RE: Permit Correction Response #2 – 3020114
 6726 Greenwood Ave N | Seattle, WA

Correction Notice #2
 Lori L Swallow
 September 4th, 2016

January 21, 12pm
With rooftop features

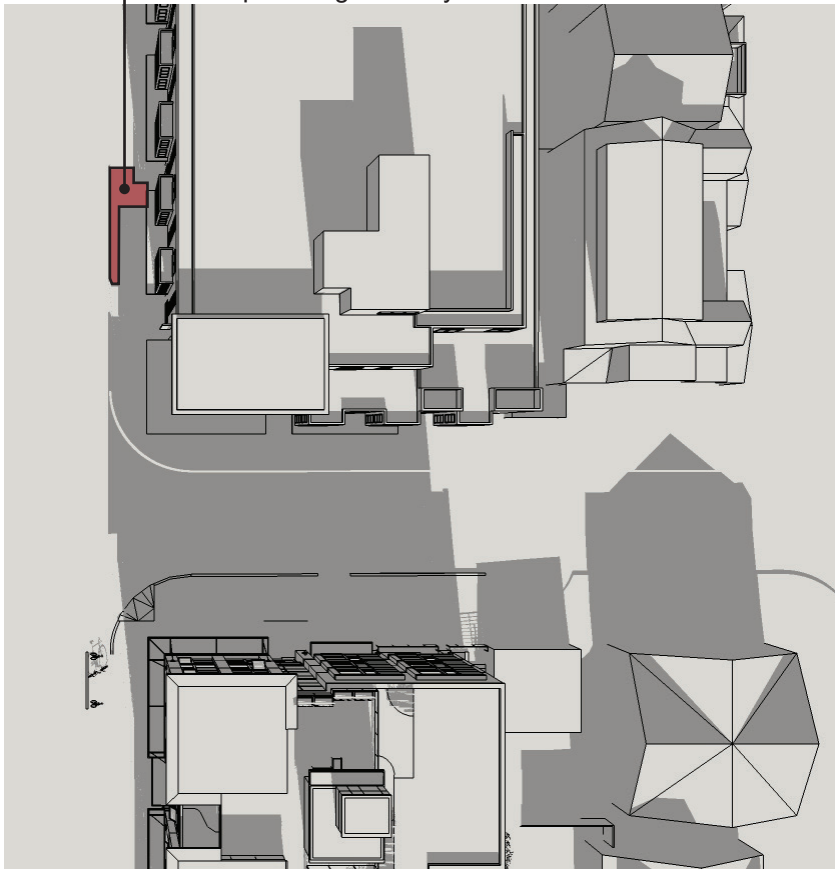
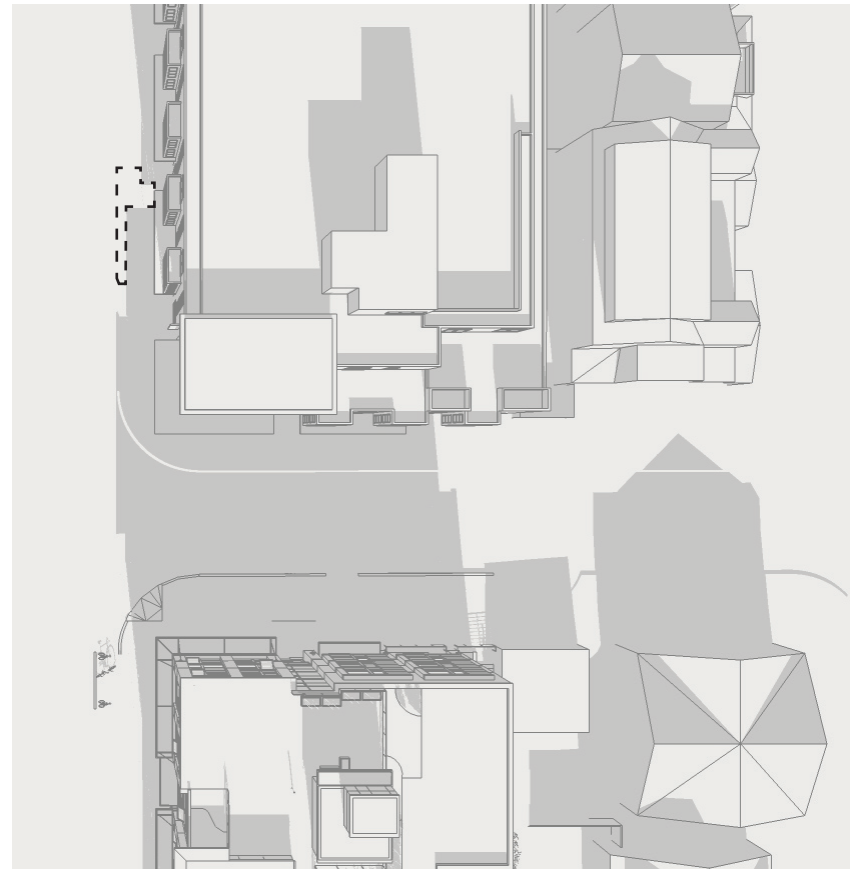
5) Floor area Ratio	FAR has been reconciled on sheet G0.02A & the Building Data on sheet G0.01.
6) Rooftop features	A shadow study showing the shadow impact on January 21 at 12pm, as indicated by SMC 23.47A.012.C7 has been provided as part of this response. The study shows the additional shadow caused by the clerestory in the Northwest corner only provides additional shade to the public right of way.

Shadow from rooftop feature
only impact of additional shadow is
within public right of way

January 21, 12pm
Without rooftop features
